Subject: LaSalle County Station Units 1 and 2
Teledyne Open Item and Error/Deviation
Reports for the LaSalle Independent
Design Review, Supplemental Responses
NRC Docket Nos. 50-373 and 50-374

Subject: Supplemental Responses for the
LaSalle Independent Design Review

Commonwealth Edison Company
LaSalle County Station - Units 1 & 2

SUPPLEMENTAL RESPONSE FOR ERROR REPORT 7

TABLE 3

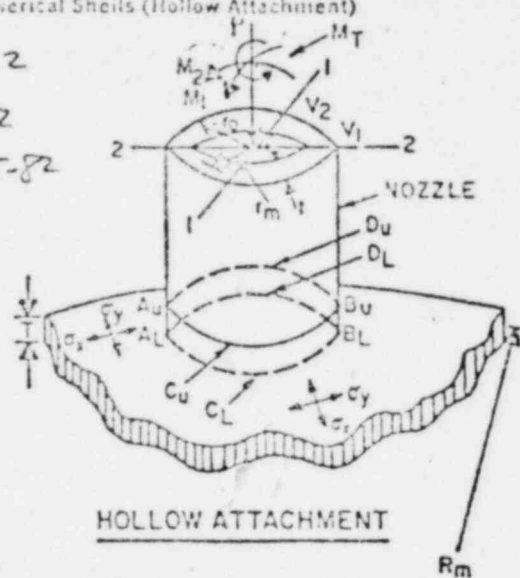
EVALUATION AT CRITICAL LOCATIONS

LPCS Pump

Location	Evaluated as Class 2		Evaluated as Class 1	
	Calculated	Allowable	Calculated	Allowable
Motor Stand	5221 psi	19250 psi	5211 psi	30000 psi
Motor Bolting	5587 psi (2) 2281 psi (2)	37500 psi 15500 psi	7449 psi	60000 psi
Suction Barrel Shell	-	-	3180 psi	37800 psi
Suction Barrel Shell at Inlet Nozzle	8195 psi	16500 psi	-	-
Suction Barrel Head/Pin Interface	5024 psi	16500 psi	5024 psi	21000 psi
Pump First Stage Casing Minimum Section	2446 psi	8250 psi	2446 psi	15000 psi
Pump Series Casing Minimum Section	3000 psi	8250 psi	3000 psi	15000 psi
Pump Series Casing Bolts	$A_m = 7.73 \text{ in}^2$ (Required)	$A_b = 11.02 \text{ in}^2$ (Available)	5617 psi	30000 psi
Pump Top Casing Bolts	$A_m = 7.65 \text{ in}^2$ (Required)	$A_b = 11.02 \text{ in}^2$ (Available)	5592 psi	30000 psi
Stuffing Box/Discharge Elbow Interface	24170 psi	31500 psi	52900 psi	63900 psi
Discharge Head Bolts	$A_m = 19.60 \text{ in}^2$ (Required)	$A_b = 19.84 \text{ in}^2$ (Available)	21676 psi	60000 psi

Foundation Bolts	12730 psi (2) 4129 psi (2)	29000 psi 11950 psi	12730 psi	35000 psi
Discharge Column	6101 psi	16500 psi	6101 psi	30000 psi
Discharge Column Bolts	$A_m = 8.73 \text{ in}^2$ (Required)	$A_b = 11.02 \text{ in}^2$ (Available)	11112 psi	60000 psi
Pump Shaft at Minimum Section	5838 psi	15000 psi	5838 psi	17500 psi

Table 3—Computation Sheet for Local Stresses in Spherical Shells (Hollow Attachment)

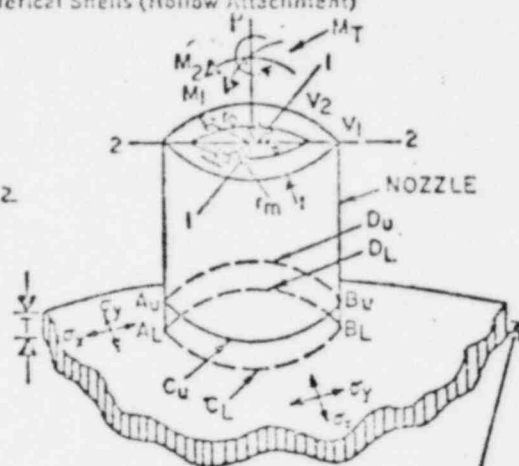
Analysis of Discharge Elbows at Stuffing Box Junction

The junction between the discharge elbow and the stuffing box is not a cylindrical nozzle but an intersection with two radii of curvature. The radius of curvature is in the transverse plane.

To accurately compute the local stresses at this junction under imposed piping loads, a detailed analysis using Bijlaard's stress tables was completed. (See attached sheets) From these calculations the worst combined stresses for the emergency loads are found to be 25763 psi at points A,B, and 19926 psi at points C,D. These stresses are well below the allowable value of $1.8S = 1.8 \times 17,500 = 31,500$ psi for emergency and $1.65S = 1.65 \times 17,500 = 28,875$ psi for upset condition.

Pr. stress = 7741 PSI

Stresses in Shells

$S = 12185$ psi (max. of σ_x)
 $S = 19776$ PSI including Pr. stress
